<b>Title - Sujet</b> Fit up GOCB	
<b>Solicitation No. - N° de l'invitation</b> EV385-173119/A	<b>Amendment No. - N° modif.</b> 002
<b>Client Reference No. - N° de référence du client</b> PWGSC EV385-173119	<b>Date</b> 2017-05-10
<b>GETS Reference No. - N° de référence de SEAG</b> PW-\$PWU-066-11068	
<b>File No. - N° de dossier</b> PWU-7-40010 (066)	<b>CCC No./N° CCC - FMS No./N° VME</b>
<b>Solicitation Closes - L'invitation prend fin at - à 02:00 PM on - le 2017-05-18</b>	<b>Time Zone</b> Fuseau horaire Mountain Daylight Saving Time MDT
<b>F.O.B. - F.A.B.</b> <b>Plant-Usine:</b> <input type="checkbox"/> <b>Destination:</b> <input type="checkbox"/> <b>Other-Autre:</b> <input type="checkbox"/>	
<b>Address Enquiries to: - Adresser toutes questions à:</b> Lee, Mony	<b>Buyer Id - Id de l'acheteur</b> pwu066
<b>Telephone No. - N° de téléphone</b> (780) 224-6675 ( )	<b>FAX No. - N° de FAX</b> (780) 497-3510

## **SOLICITATION AMENDMENT 002**

**1.1 ADDENDUM FORM**

# **Project R.075025.004**

# ACCESS CONTROL – ELEVATION OF SINGLE DOOR WITH DOOR CONTACT, FRAME MOUNTED READER AND ELECTRIC STRIKE

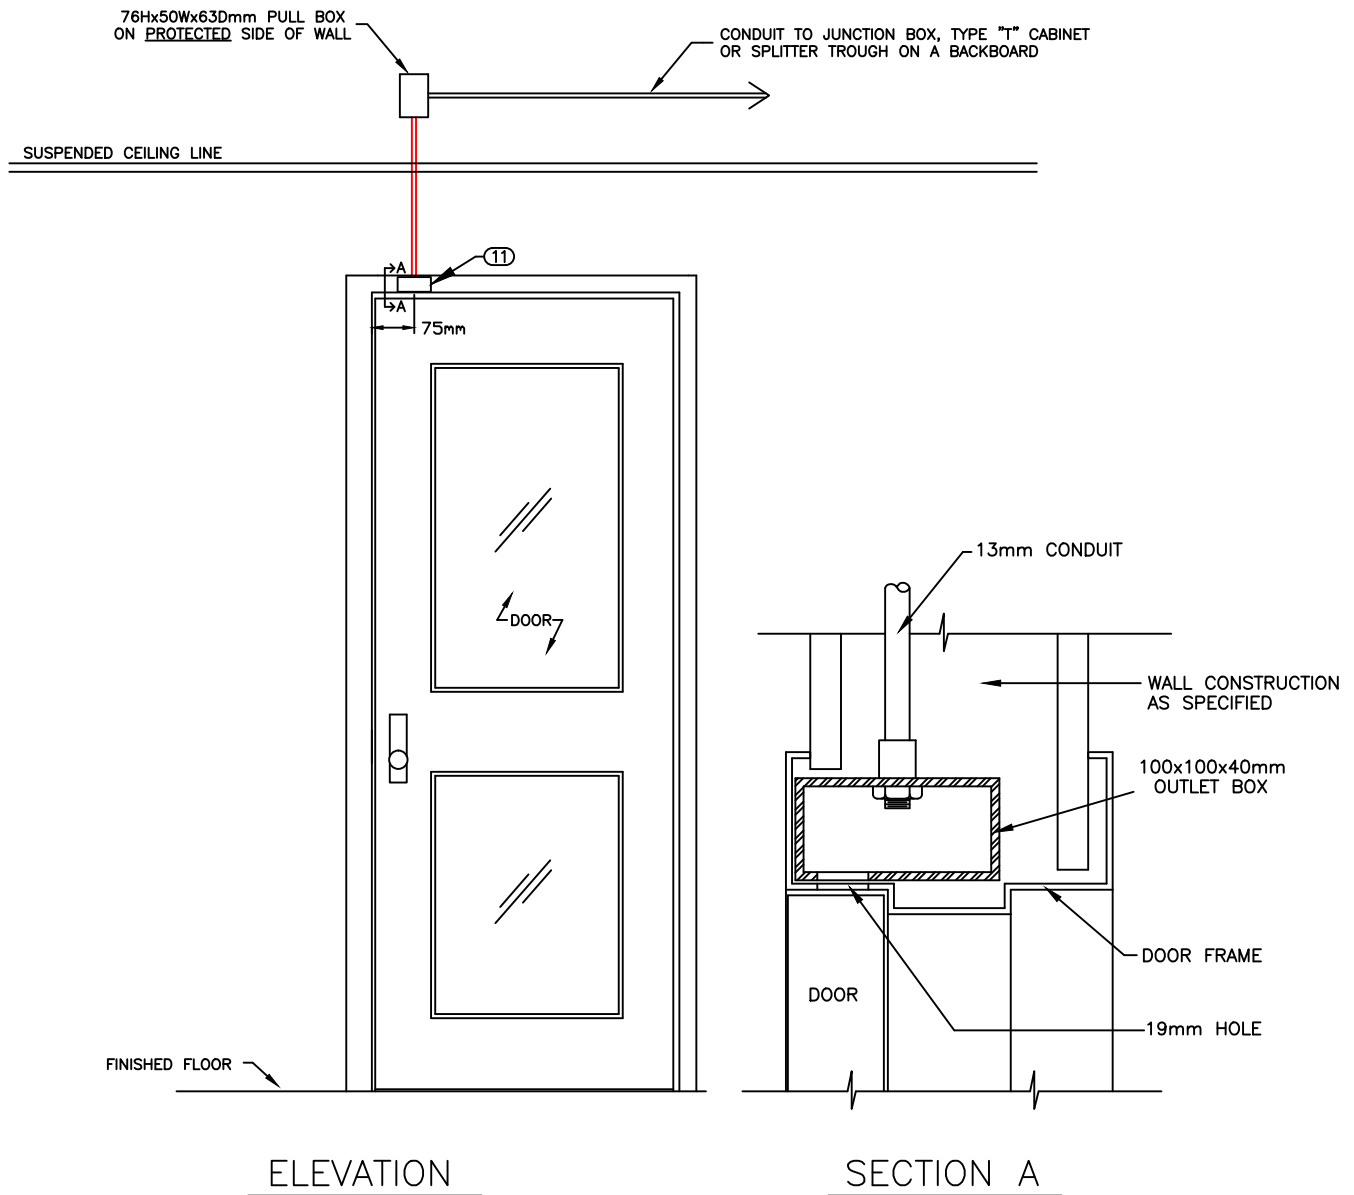
- .1 Drawing 3/A3: **REVISE** conduit system for the security system devices to match the attached documents.

DRILL A 19MM HOLE AT 75MM (CENTER POINT) FROM THE EDGE OF THE DOOR CASING TO ALLOW FOR DOOR SWITCH INSTALLATION AND ACCESS TO WIRING.

CONDUIT CONNECTOR TO BE MOUNTED AND FASTENED TO THE OUTLET BOX BY DOOR FRAME FABRICATOR.

OUTLET BOX TO BE SPOT WELDED IN PLACE BY DOOR FRAME FABRICATOR.

DRILL A 19MM HOLE AT 75MM (CENTER POINT) FROM THE EDGE OF THE DOOR CASING TO ALLOW FOR DOOR SWITCH INSTALLATION AND ACCESS TO WIRING.
